Lower Snake River Dams Breach Mitigation Plan & Cost

Prepared by Jim Waddell, Civil Engineer, USACE Retired, John Twa., ME., Chris Pinney, Fish Biologist USACE Walla Walla, Retired

December 2020

Executive Summary- Breach Plan and Costs

FIGURE 5: LOWER GRANITE DAM BREACH PLAN (AERIAL VIEW)

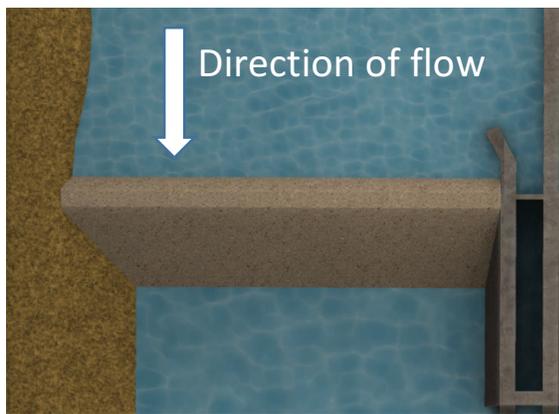
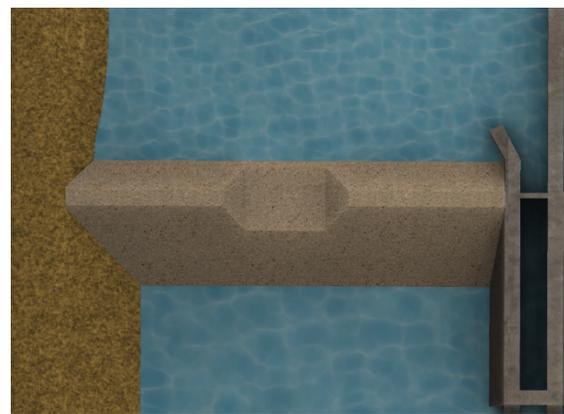
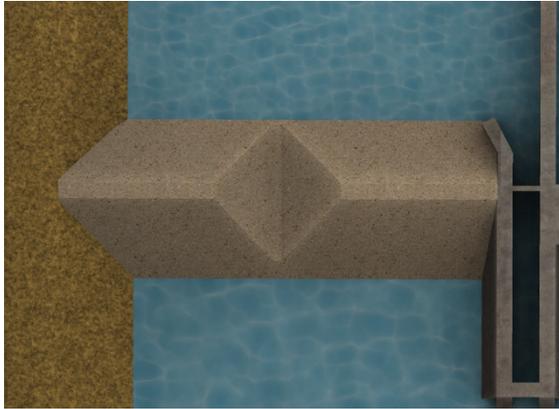
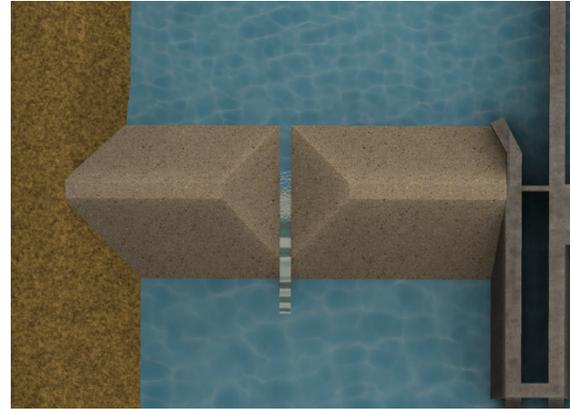
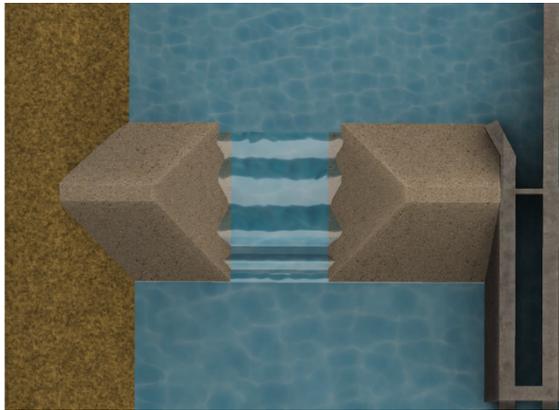
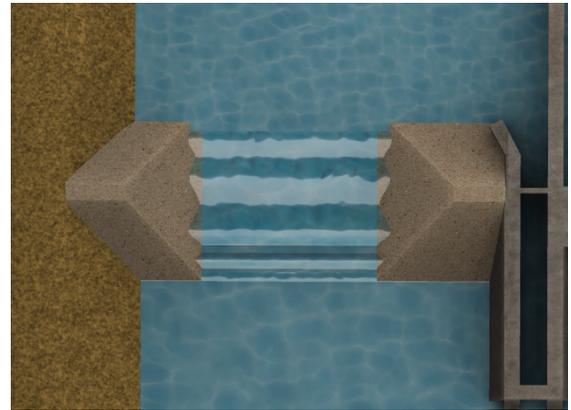
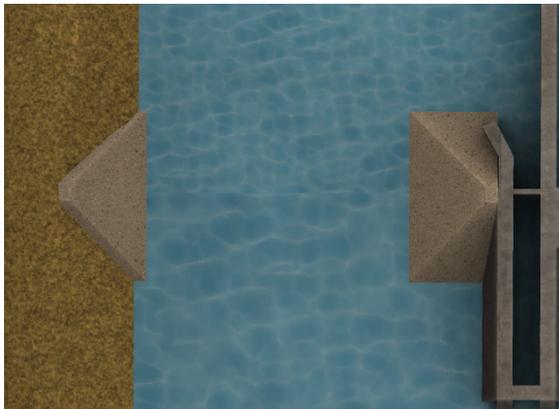
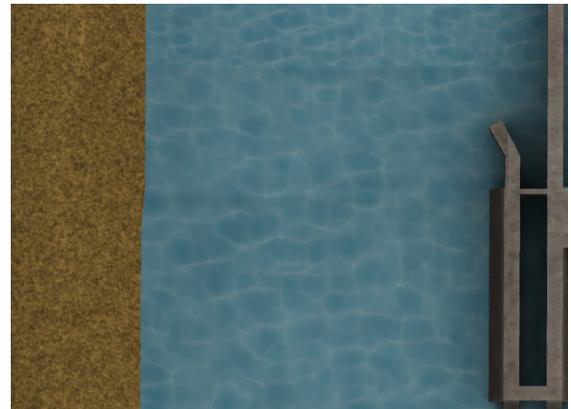
The LSFR Appendix D & Annex B assumed that the breach would be accomplished by removing the embankment material to an offsite location up to 2 miles away. Given the short duration required to excavate/move the material, a large force of oversized equipment was necessary, working two 10 hour shifts 6 days per week. This plan provides for a much simpler and cost effective approach. Prior to drawdown on 1 November, the road and other infrastructure will be removed and the riprap on the downstream side of the dam will be pulled down and loaded on barges for possible use as dike material (See River Channelization.) Given the sand and gravel nature of most of the material, which is the same or similar to normal bed material as the 100 million cubic yards deposited at the confluence of the Clearwater and Snake, embankment removal will begin with two D-8 dozers and one large bucket loader pushing the embankment material over the downstream slope until the earthen berm is lowered 80 feet. At this point a controlled hydraulic breach will begin by closing the turbine wicket gates. As the water level rises and flows through the embankment cut, hydraulic erosion will cause a headcut in the embankment to migrate upstream for ~5 hours until it meets the upstream face. At this point discharges peak at 150,000 cfs for about 15 minutes and drop off to 50,000 cfs (natural river flows) over the next 3 hours as the notch or embankment opening widens. Figure 3 shows the breach flows and channel widening in the first 24 hours following breaching. Figure 4 shows channel widening over time with increasing flows. Widening will continue with the higher flows in early spring. It will reach a stasis width of 400+ feet with flows of 120,000 cfs, and 700+ feet with flows of 200,000 cfs. Hydraulic modeling shows that notching the embankment will be the most cost effective and predictable method. Figure 5 illustrates the breaching process.

eliminate any need for cofferdams. By notching the earthen embankment and beginning hydraulic breaching next to a thinned section of abutment, it is likely that the high flow rates experienced in the first few hours of breaching will remove a great deal of the remaining abutment material, especially given its location on the outside curve of the new channel. This will direct the flows into this material first. Soil studies will confirm this. Conservatively, the estimate assumes most of the originally planned mechanical excavation will be required.

Regarding the efficacy of allowing the breach process to move embankment and abutment material downstream, this is mostly a sandy gravel material like the bed load normally found in the river. It is nearly the same material deposited in the confluence, much of which will migrate downstream in far greater volumes than will be eroded from the earthen embankments. This material is an essential part of the restored natural river channel system and helps form desirable salmonid habitat. It is assumed that a portion of the material in the confluence will remain there indefinitely. This likely will be 10% to 20% based on evidence from the Elwha River. About half of this can be made up from the material eroded from the dams, thus getting the bed load volumes closer to historical conditions. In short, this is beneficial material and keeping it in the river is beneficial, much like the material dredged from the confluence and deposited in river for Chinook habitat. Furthermore the original plan covered in the 2002 LSRFS/EIS uses hydraulic removal for much of the dams below a head elevation of 22 feet, see pages D5-3 and See D-B-10 & 11, and discusses sediment movement and impacts. Thus the original EIS covers the concept of hydraulic breaching. It is also believed that the assumptions in the original plan regarding excavation of material between the cofferdams “in the dry” are not realistic given the drawdown speed and inability of the soil to dry quick enough. As noted on these pages of the EIS, it was anticipated that river flows would move more than just coffer dam material, which did not increase the silt load enough to have much impact.

Photo of Lower Granite Dam taken during dam construction. The channel existed in this configuration for several years.

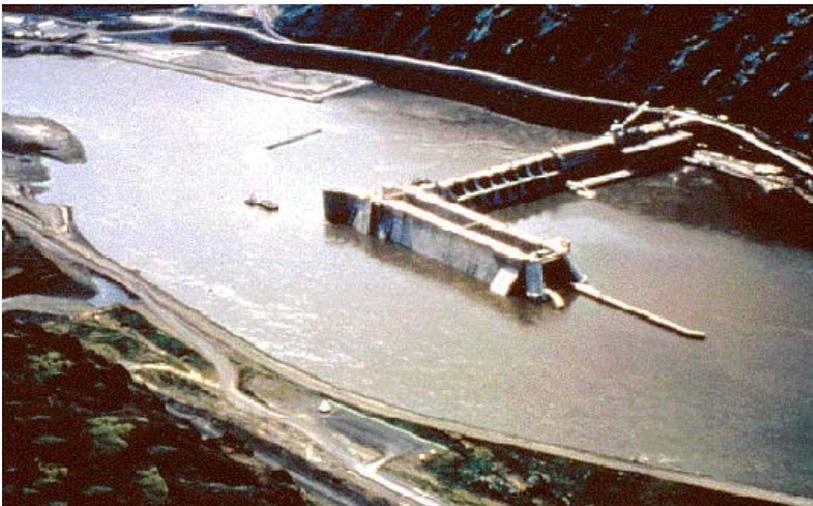
The LSFR Appendix D & Annex D channelization plan provides for upstream and downstream diversion levees to create optimum hydraulic conditions around the concrete structures. While it is entirely possible that sediment deposits (approximately 100 million cubic yards) eroding from the confluence could settle out and infill the area in front of the dams, a contingency estimate will remain in place to cover the cost of a full levee structure on the upstream side. In addition, photographs taken at the time of dam construction show that the river was diverted around the dam construction area by diversion dikes and fill. Contemporary subsurface evidence at Lower Granite dam shows that these elevated construction staging areas are still in place and are at an elevation above normal river stages. This is likely also the case at the other three dams. However, this work will not commence until completion of drawdown and observed river conditions and sediment deposits are taken into consideration. The upstream toe area of the navigation lock may require armoring. The downstream levee will be omitted from the cost estimate as its contribution to salmon bypass is likely negligible. This will reduce the amount of stone required to divert the river. The riprap on the downstream face of the dam will be salvaged, placed on barges, locked through, and stock piled for potential use on the diversion structure and/or armoring. Additional riprap can be salvaged from embankment protection, which will be at least 80 feet above natural river level in this area. These factors further reduce the estimates for the upstream diversion structure. Sounding prior to construction will determine the need for this stone and diversion material.
